Re. Planning Application by the National Transport Authority for the construction of the Bray to City Centre Core Bus Corridor Scheme.

The Submission from Dun Laoghaire Rathdown County Council regarding the Bray to City Centre Core Bus Corridor Scheme is set out hereunder.

From: Dun Laoghaire – Rathdown County Council,
Marine Rd, Dun Laoghaire, Co. Dublin, A96 K6C9.

Example 1

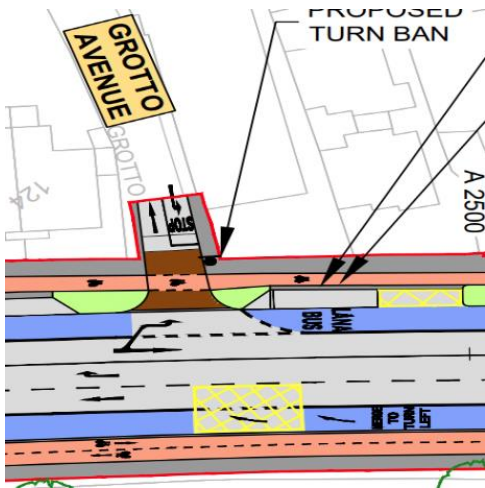
In the interest of pedestrian and cyclist safety, DLRCC has a requirement, where feasible, for the provision of continuous pedestrian and cycle facilities across side roads, similar in design to that proposed under the Blackrock to City Centre CBC scheme at Grotto Avenue (example 1 below). At other side road locations across the Bray to City Centre CBC scheme however, the cycle lane is at grade with the general traffic lane and not accommodated on the raised table (example 2 below).

DLRCC requests that the Board include a condition requiring prior engagement and agreement with DLRCC regarding the final design of the pedestrian and cycle facilities at junctions with side roads in order to ensure an approach which is consistent with the requirements of the Council and the latest version of the Cycle Design Manual.

Straight Through Cycle Movement

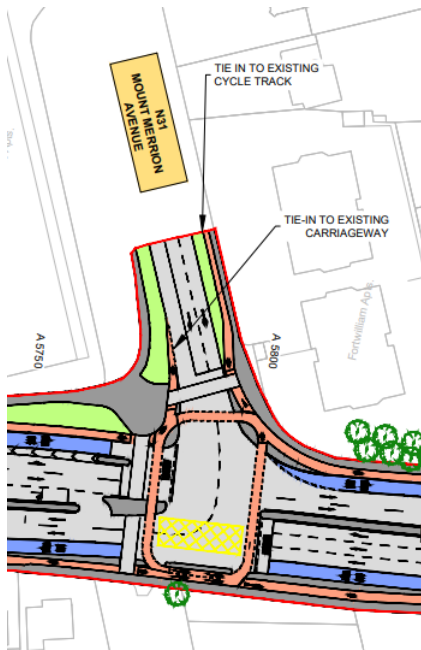
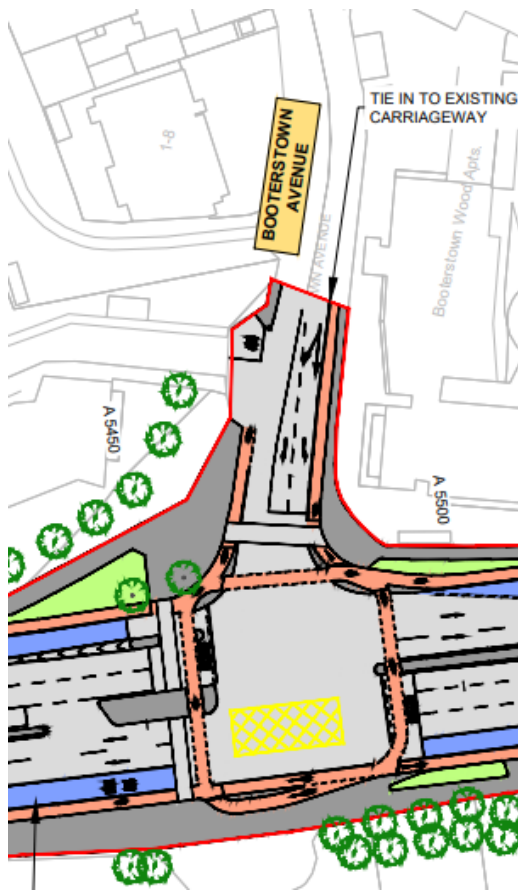
With reference to Sheet Nos. 17 & 18, which include junctions at Booterstown Avenue and Mount Merrion Avenue, shown below, consideration should be given to allowing straight through cycle movements on the side of the junction that presents no motorised traffic conflicts provided that pedestrian movement can be safely accommodated.

DLRCC requests that the Board give due consideration to allowing straight through cycle movements to bypass junctions where feasible.
